15 NOISE AND VIBRATION

15.1 OLYMPIC DAM REGION

Figure 15.1 Predicted noise contours at the desalination plant

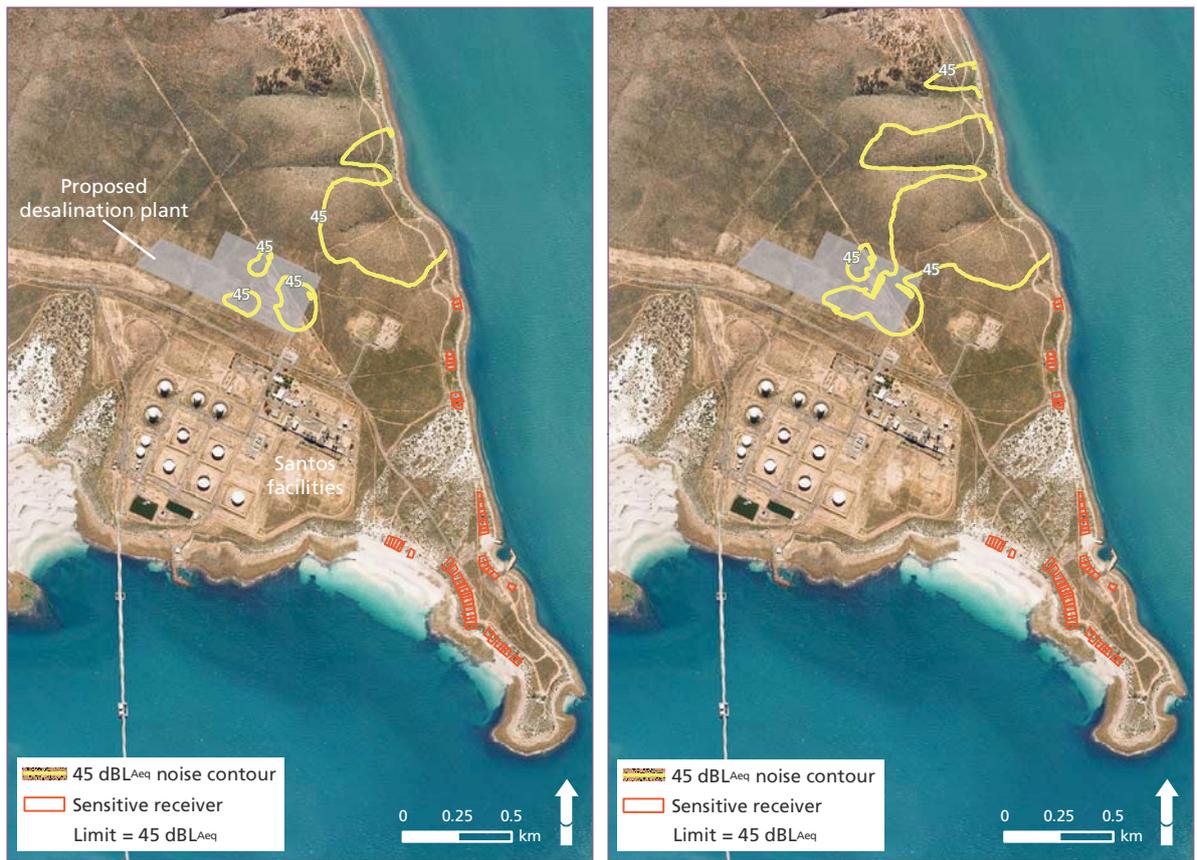
A baseline assessment of noise levels in the area of the proposed desalination plant was undertaken in July 2007, and the results were summarised in Table 14.7 of the Draft EIS and detailed in Sections D3 and D4 of Appendix M of the Draft EIS. It was acknowledged in the Draft EIS that winds were high at the time that background noise levels were measured and, potentially as a result of the high wind velocities, noise from the existing industrial facilities was audible only occasionally at the measurement locations (with these locations being the nearest residences to the proposed desalination plant infrastructure). On this basis, the validity of the baseline noise monitoring has been questioned.

It was suggested that the desalination buildings should be fabricated from concrete in a manner similar to that of the Perth desalination plants. The noise model developed for the proposed desalination plant (refer Section 14.4.1 of the Draft EIS) included the base case assumption that the desalination buildings would be enclosed in a corrugated iron clad building. The resultant predictions of noise levels at nearby receivers (refer Section 14.5.2 of the Draft EIS) indicate that the applicable noise criteria would be easily met using this building construction methodology. The actual design of the desalination buildings, including the choice of construction material, would be finalised at a later stage.

However, as also noted in the above-mentioned sections of the Draft EIS, in addition to the attended noise measurements, a noise data logger was used together with an ultrasonic wind meter, also connected to the data logger. This equipment was run continuously for two days, and allowed the noise levels to be correlated with the wind speed measurements to ensure that an accurate baseline representing the noise level with no wind was established. The average zero-wind-speed noise levels at the Point Lowly monitoring location measured on the data loggers was 33 to 35 dBL_{Aeq} , significantly lower than the 41 to 42 dBL_{Aeq} during attended measurements. Moreover, the zero-wind-speed levels were used to calibrate the model that was developed to predict noise levels from the proposed desalination plant.

The lack of audible noise from the existing industrial facilities does not influence the outcomes of the impact assessment as compliance with the Environment Protection (Noise) Policy 2007 is required for each individual operation. The results of the modelling for the proposed desalination plant (as presented in Figure 14.3 of the Draft EIS in the Supplementary EIS as Figure 15.1) indicate that noise levels would be low, and the plant's operations would typically be inaudible at the closest residences.

Figure 15.2 Predicted noise levels from the proposed landing facility

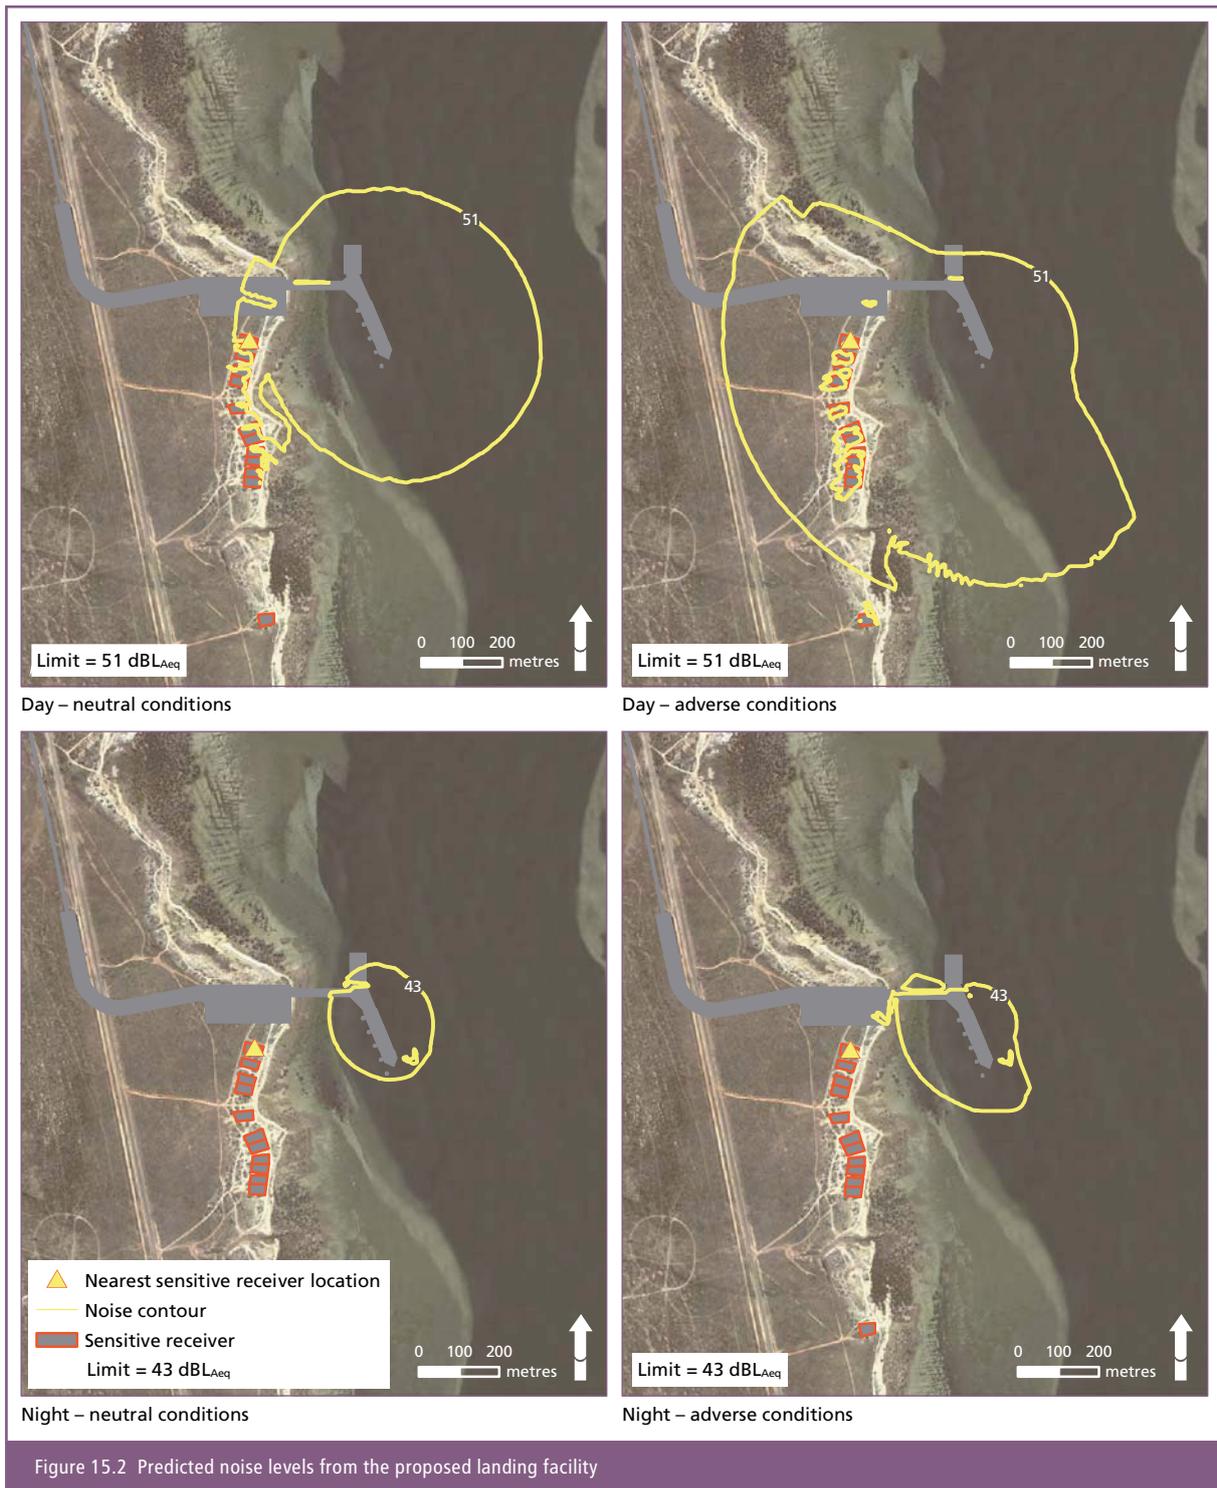
Concerns were raised regarding the potential noise and vibration impacts on the residences surrounding the proposed landing facility, and the adequacy of the noise impact assessment presented in the Draft EIS. Specific issues related to:

- the nature and level of the predicted noise
- the assumptions and criteria used for the assessment
- the options for noise mitigation.

The results of acoustic modelling of the likely noise sources at the proposed landing facility were discussed in Section 14.5.2 of the Draft EIS, and indicated that the noise criteria would likely be exceeded at residences up to 450 m away during neutral meteorological conditions, and 750 m away when the wind was blowing from the landing facility to the residences (see Table 15.2 and Figure 15.2 of the Supplementary EIS).

The results of the revised modelling indicate that reducing the barge noise level by between 6-13 dB would be sufficient to meet the more stringent SA EPA noise criteria at all of the potentially affected residents for all meteorological conditions (see Table 15.3 and Figure 15.3).

BHP Billiton would install noise attenuation and mitigation to landing facility equipment and infrastructure as necessary to comply with the SA EPA criteria. Options for the reduction of noise levels from the barge and other landing facility sources are discussed in the following Section.

Figure 15.4 Shack Road daily traffic profile (2019)

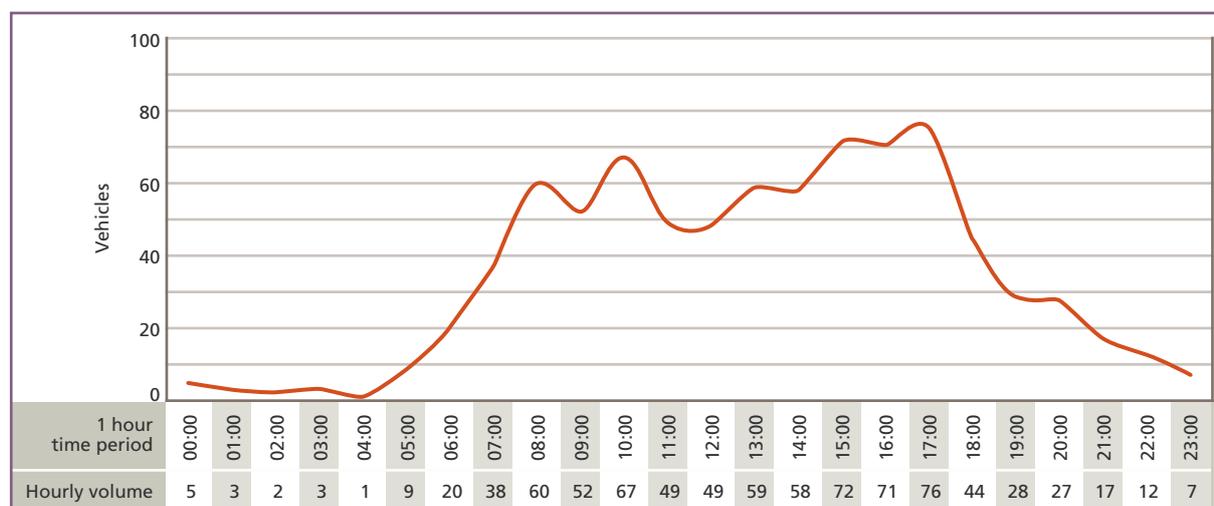
Further information was sought regarding expected noise and vibration levels at residences adjacent to the access corridor and pre-assembly yard.

expansion during which landing facility-related peak traffic movements would occur (see Figure 15.4 of the Supplementary EIS). This indicated approximately 760 vehicle movements per day, concentrated largely between 8am and 5pm. The proposed access corridor would result in an additional five to 10 movements per week, and approximately 10 light vehicles per day (or a total traffic increase of approximately 0.5%) when a vessel was at the landing facility (one vessel would arrive about every 11 days and remain for about three days).

As a result of the distance between the nearest residence and the access corridor (about 100 m) and the relatively minor increase in traffic, it is expected that the increase in noise and vibration levels would be insignificant. For context, a doubling (or 200% increase) of traffic volumes typically results in an increase in noise of around 3 dBL_{Aeq}, generally considered to be the level below which changes in noise levels are imperceptible.
